Access Compliance Report

Public Rights-of-Way

Intersection ID: 27942	Main Street: COMMUNITY_HOUSE_RD	Cross Street: NORTH_COMMUNITY_HOUSE_RD	Location: NE
ADA ID: AD9BA231CB04	Ramp Type: BlendTrans1	Initial Pass/Fail: Fail	Overall Compliance: No
Severity Score: 12.5			
Codes/Mitigation Info/Possible Solution		Field Measurements/Component Compliance

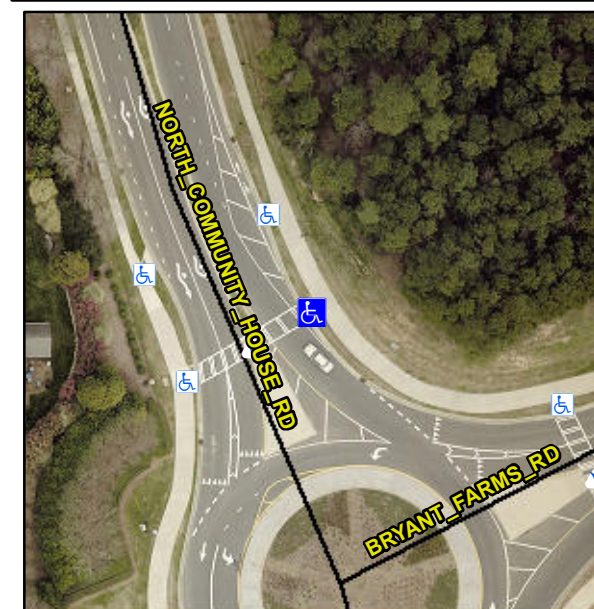
Not Found, R304.5.3

Remove & Replace Curb Ramp With Two New Directional Ramps or Equivalent.
